14 Avenue N.W. Reconstruction and Mobility Improvements

Phase 2: What We Heard Report

Prepared by:
The City of Calgary Engage Resource Unit

Segment 3 - North Hill Centre pedestrian overpass to 14 Street N.W.

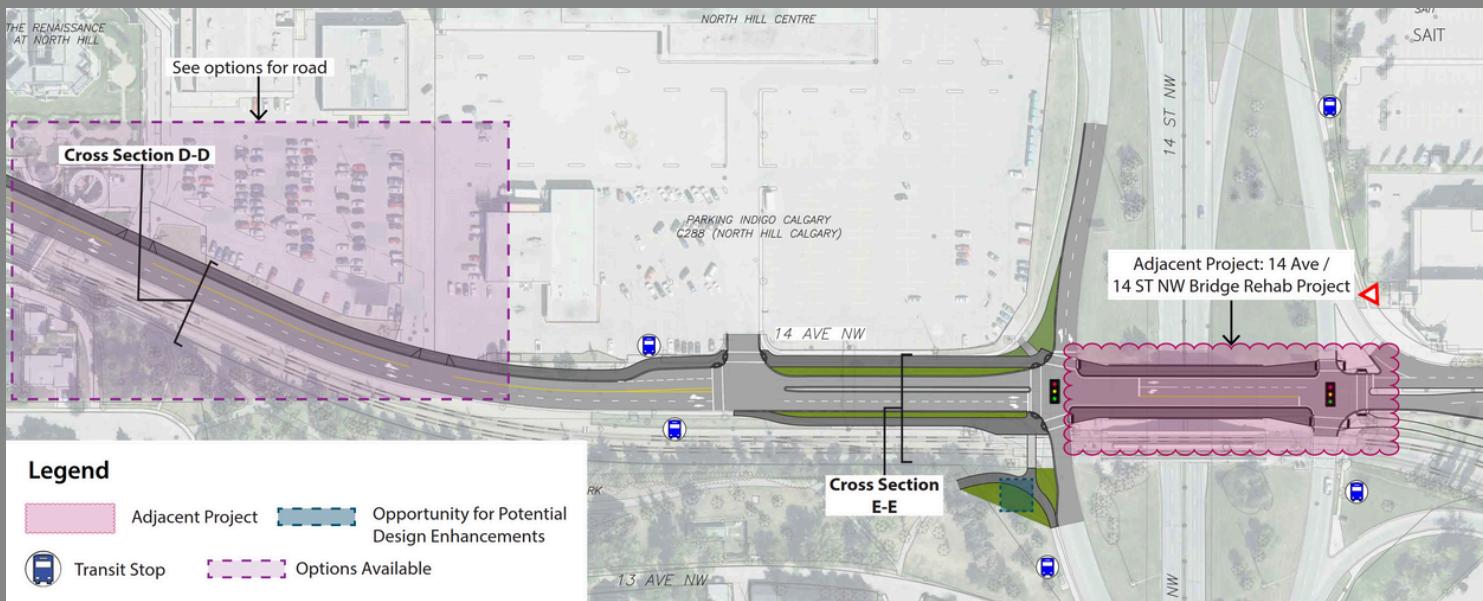
Theme	Sample Comments
Pedestrian Safety	<p>[Rated 3] Narrower driving lanes is good. Other traffic calming measures would be great, like speed bumps or at least raised crossings. Also having the pathway continue across driveways would be great. That way there's a visual reminder to drivers that they're entering ped/bike space.</p> <p>[Rated 1] If there is more use of public transport and more people using the services at North Hill Mall, I do not see keeping bikes and pedestrians together as a good idea. With more people using the buses and more bikes, some of them electric (usually faster), there is a potential for accidents.</p> <p>[Rated 3] Multiuse pathways may be safer for cyclists, but they aren't safer for pedestrians.</p>

Theme	Sample Comments
Landscaping	<p>[Rated 3] I would like to see more landscaping improvements on the west pathway too. No one likes walking next to a road and parking lot without any trees for shade in the summer.</p> <p>[Rated 4] If more boulevard is being added on the north side of 14th Ave, be sure to include trees, as currently this is a boring unshaded walk.</p> <p>[Rated 4] I like the wider sidewalks and beautification with trees. Would be much improved over the vast concrete/asphalt expanse.</p> <p>[Rated 3] would be keen to see some green space on the north of 14 Ave. as it is rather depressing and concrete as it is now.</p>

Theme	Sample Comments
Connectivity	<p>[Rated 3] Connectivity for cyclists crossing over 14th avenue towards SAIT is a concern to me - will there be a continued pathway on the north side of 14th avenue east of this segment? or will cyclists have to cross to the south and join eastbound vehicle traffic into SAIT?</p> <p>[Rated 3] my biggest concern is where do cyclists go after they cross the bridge? The City should give priority to developing longer bike paths that are designed for everyday commuters so they can navigate the city in a safe manner and without having to deal with bike lanes that suddenly stop and dump the cyclist into the traffic flow</p> <p>[Rated 4] For the sidewalk coming out of Lions Park just south of the tracks, make sure that the pedestrian route is direct to the tracks crossing, rather than angling away from the crossing (so we pedestrians end up cutting a corner where the path should be).</p>

Theme	Sample Comments
Other suggestions	<p>[Rated 1] Improve the existing pathways on the green area South of the LRT, instead putting a path alongside 14 Ave. It will be healthier and nicer for pedestrians and bikes.</p> <p>[Rated 3] Would prefer to see improved connectivity for cycle/pedestrians on the south side (Lion's Park) - this is still a much more pleasant way to travel along 14th avenue.</p> <p>[Rated 4] Disappointed that some of the budget isn't addressing the pedestrian overpass' bad state of maintenance, and its issues with the pathway in Lions Park. Again, more activity in Lions Park would be good, and isn't promoted here.</p>

Segment 3 Options: North Hill Centre pedestrian overpass area

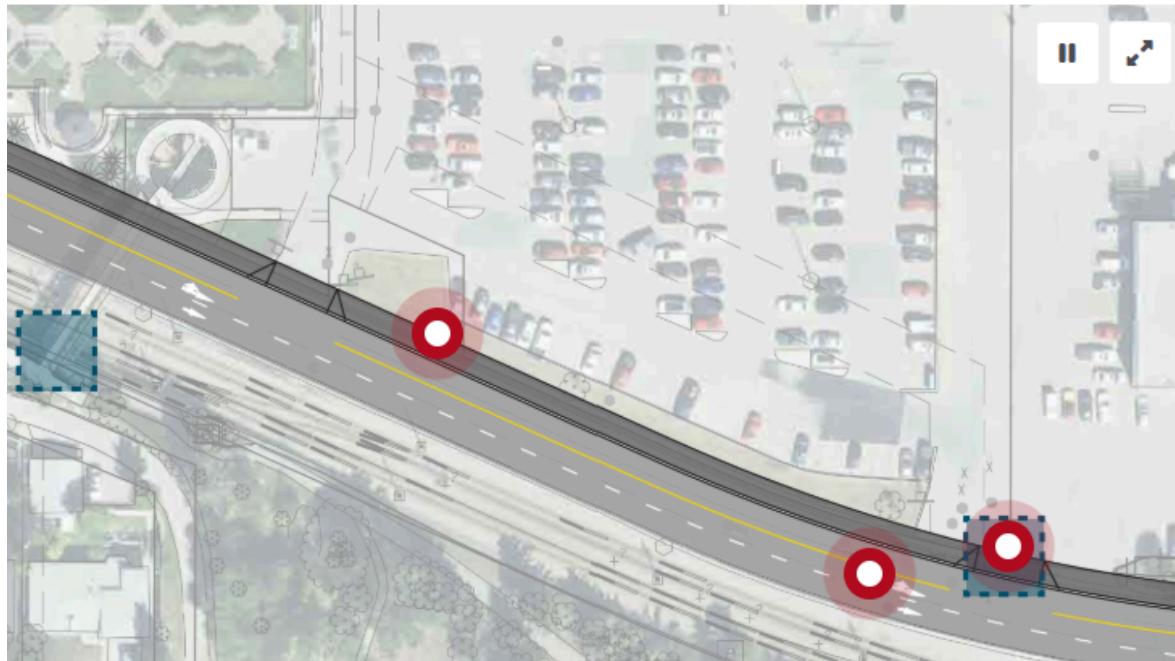
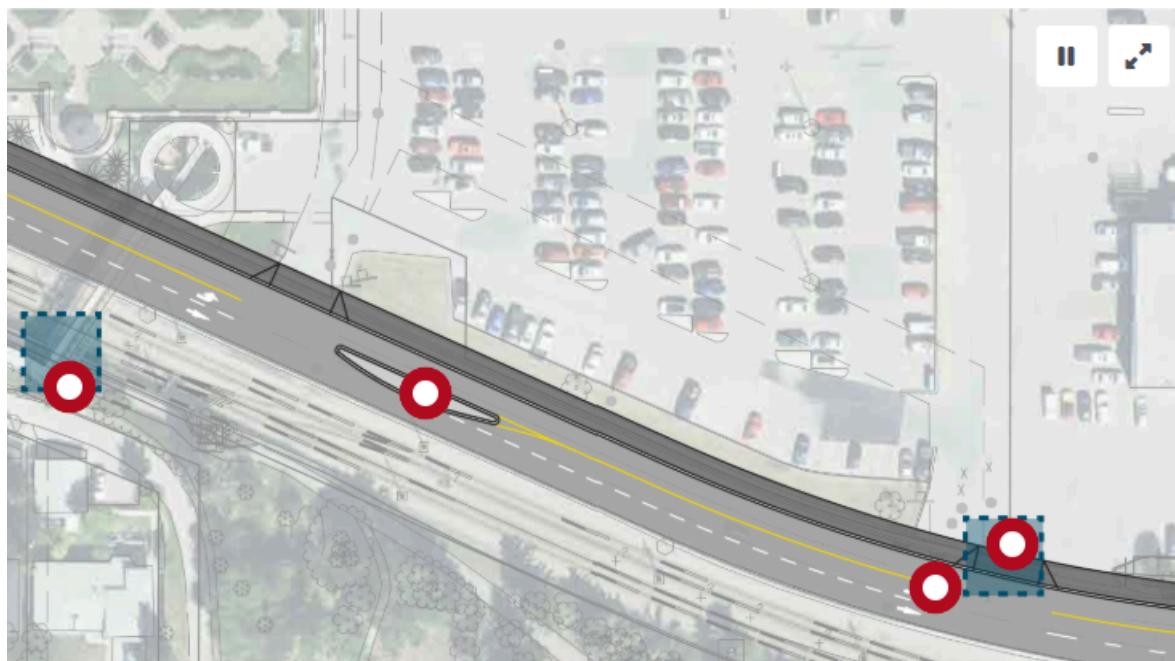
Theme	Sample Comments
Raised median	<p>[Option 1 rated 2, Option 2 ranked 5] Only major difference is the median, but it's a big one. In providing protection and clarity for those turning into North Hill, it not only makes the area safer, but reinforces the idea of the street as a means to arrive at a destination, rather than somewhere to move through.</p> <p>[Option 1 rated 2, Option 2 ranked 1] No raised medians please squeeze the road instead. add a chicane.</p> <p>[Option 1 rated 5, Option 2 ranked 2] I prefer option 1 because raised median islands always seem like an unnecessary obstruction to me, because a vehicle that is slightly off-course in the lane can collide with the island. This is especially true in winter, when it's difficult to effectively remove snow around the island, so that the island is sometimes hard to see and drivers might not know it's there.</p>

Theme	Sample Comments
Improvements to sidewalks	<p>[Option 1 rated 5, Option 2 ranked 1] waste of time and money - only the sidewalks need to be fixed for wheelchairs those of us on bicycles/scooters use the Lions Park pathways instead STOP WASTING OUR TAXPAYERS MONEY!</p> <p>[Option 1 rated 2, Option 2 ranked 3] Creating some raised crossings / continuous sidewalks midblock would be nice. The ped bridge is horrible for accessibility and I'm gonna cross wherever I want, anyways.</p> <p>[Option 1 rated 1, Option 2 ranked 3] It's safer for those walking and wheeling if driveway access into north hill is consolidated. If that can't be done - can continuous sidewalks be implemented as a physical reminder that vehicles are entering a space where people are walking and wheeling?</p>

Theme	Sample Comments
Left turn lanes	<p>[Option 1 rated 4, Option 2 rated 5] I like that both options consolidate turn opportunities... currently there are many places where vehicles may turn, which makes it tough for cyclists who have to keep stopping to allow them to turn.</p> <p>[Option 1 rated 4, Option 2 rated 5] I like the version that has distinct left turn lanes, and cuts down on weaving of traffic (but the current version is OK also, important thing is to keep the left turn lanes, as you have).</p> <p>[Option 1 rated 3, Option 2 ranked 4] I like the dedicated turn lane. Is there room for an EB Cycle track with either of these configurations?</p> <p>[Option 1 rated 5, Option 2 ranked 1] the disconnected left turn lanes will create confusion in option 2.</p>

Theme	Sample Comments
Other suggestions	<p>[Option 1 rated 3, Option 2 ranked 1] explore options to have two lanes going West, one for vehicles passing by and another for access to the mall, library, residential towers, Safeway, etc.</p> <p>[Option 1 rated 3, Option 2 ranked 5] reduce weaving. 1 travelling lane + 1 turning lane is necessary & sufficient for this area</p> <p>[Option 1 rated 2, Option 2 ranked 1] you don't need two eastbound driving lanes. Make one of them a dedicated bus lane.</p>
